EXPLANATION OF INTENDED EFFECT

Proposed amendment to State
Environmental Planning Policy
(State Significant Precincts)
2005

INFRASTRUCTURE NSW

21 December 2021

Figure 13 Central Barangaroo Envelope Plan (west elevation)

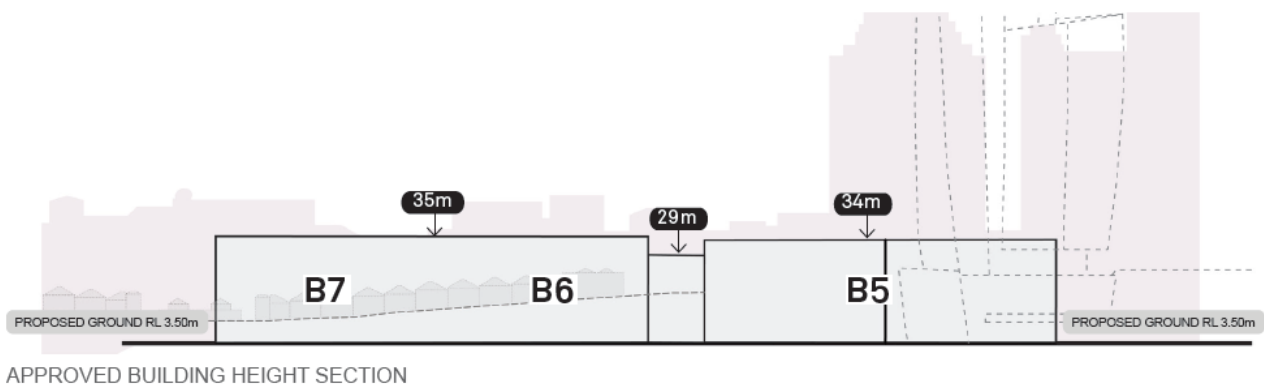
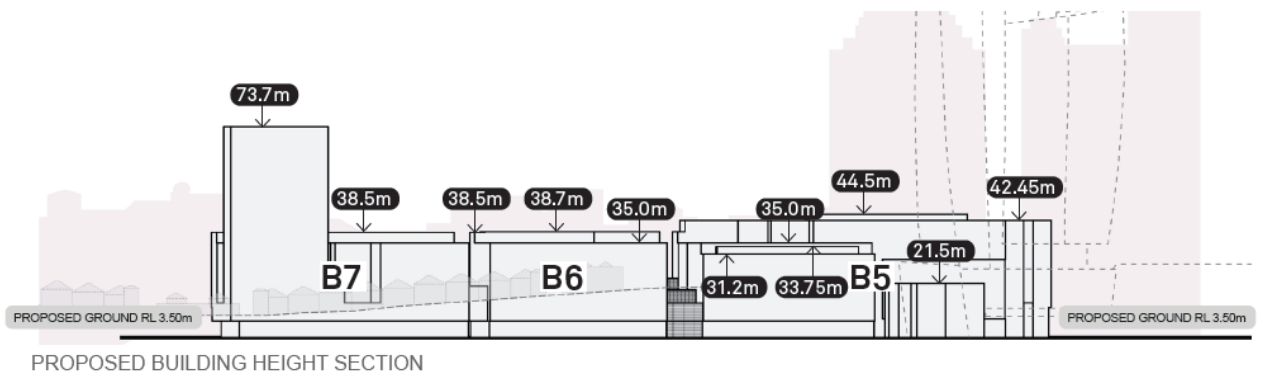
The existing Height of Buildings Map specifies one maximum building height RL for each of the three development blocks as follows Block 5 – RL 34m, Block 6 – RL 29m and Block 7 – RL 35m. As demonstrated in Figure 12, this presents as a solid mass which features little to no articulation in built form.

Conversely, the proposed amendment to the SSP SEPP seeks to allow for a more modulated built form and massing at an appropriate scale, as well as a greater variation in height across Central Barangaroo. Building heights across Blocks 5, 6 and 7 are proposed to be amended to generally align with the Central Barangaroo Envelope Plan (prepared by Hassell, dated June 2021). The Central Barangaroo Envelope Plan (as illustrated in Figure 13, Figure 14 and Figure 15) aligns with and will sit within the parameters of the proposed amendments to the Height of Buildings Map.
